RE: Medians at Liberty Park - Reduced Safety - Increased Risk

Example 2: Median on Alameda between Prospect and Liberty Park

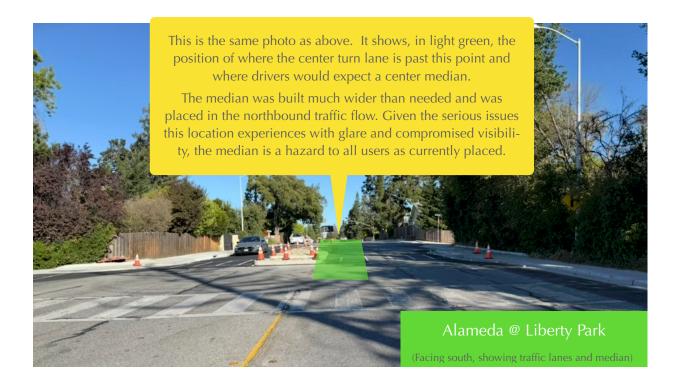
This sharp pointed curb corner has a high likelihood of causing tire and wheel damage, leading to tire failure. It seems that a rounded or ramped corner would be safer and less damaging.
